ADDENDUM NO. 1

March 19, 2025

School District of Haverford Township | Coopertown Elementary School Renovations & Additions
CRA Project No. 3758

LANDSCAPE PLAN

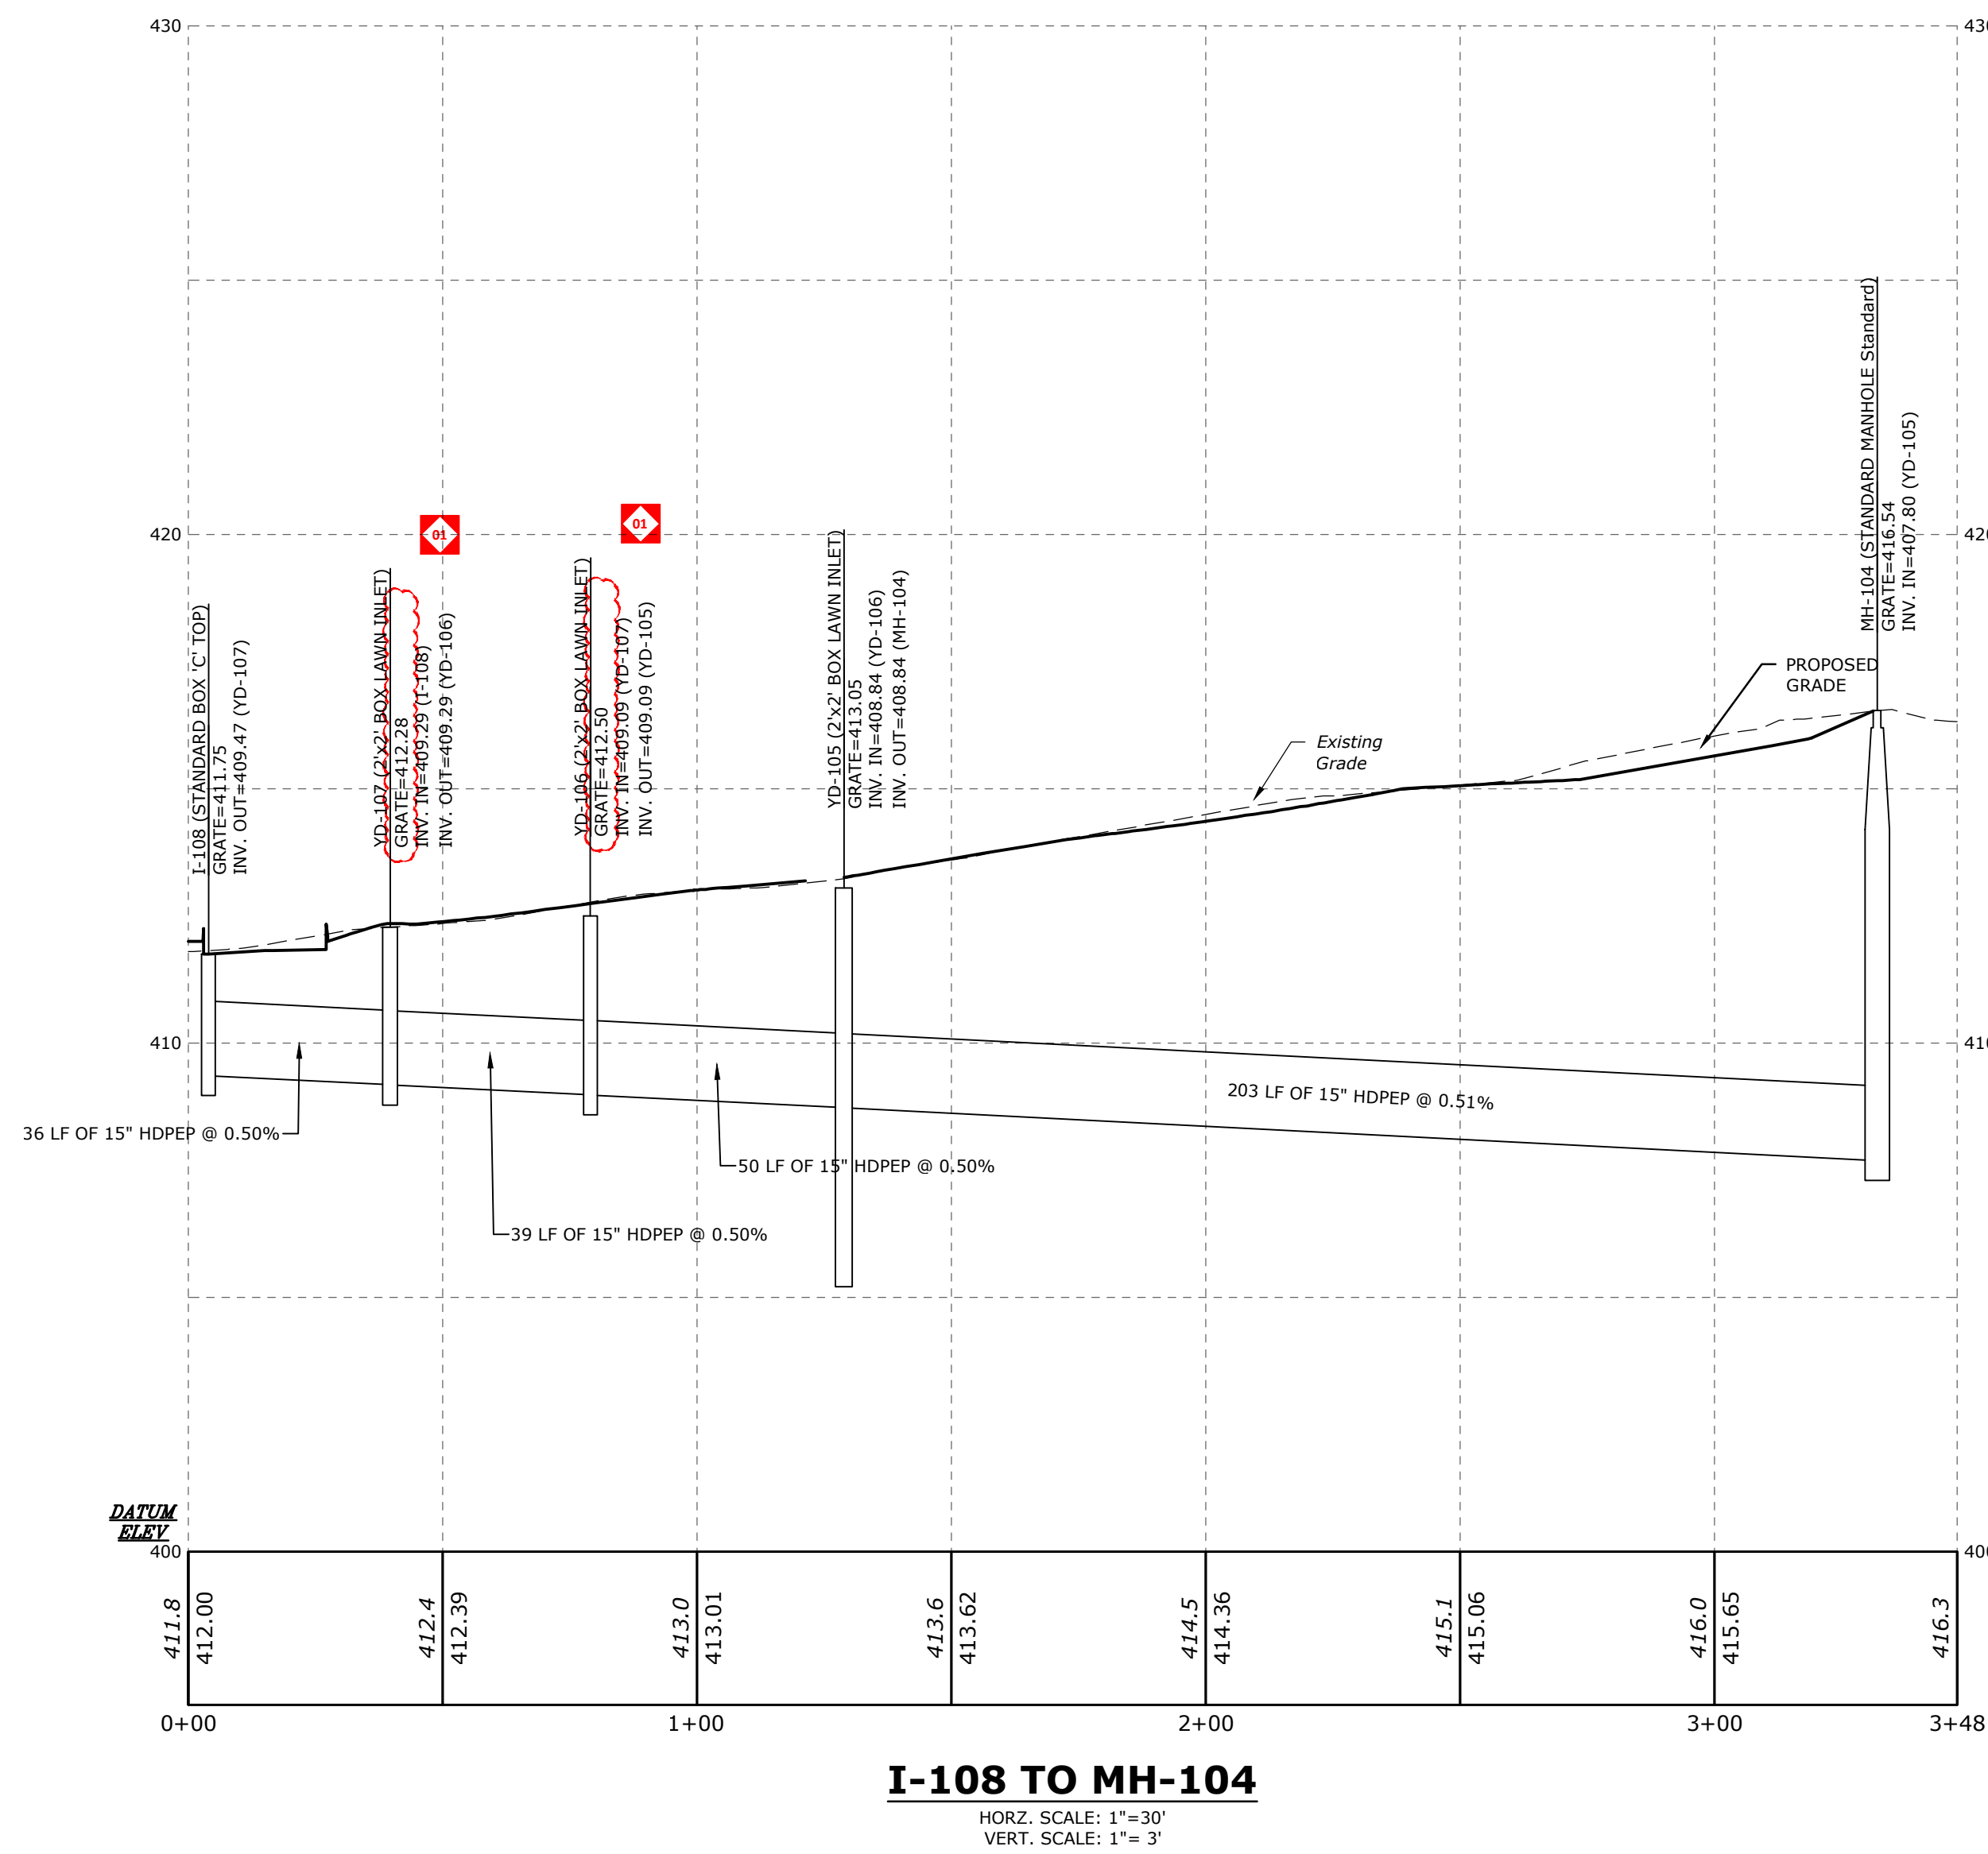
1. Move trees away from sidewalk.
2. Add tree fence protection
3. Revise Limits of Disturbance near flagpole
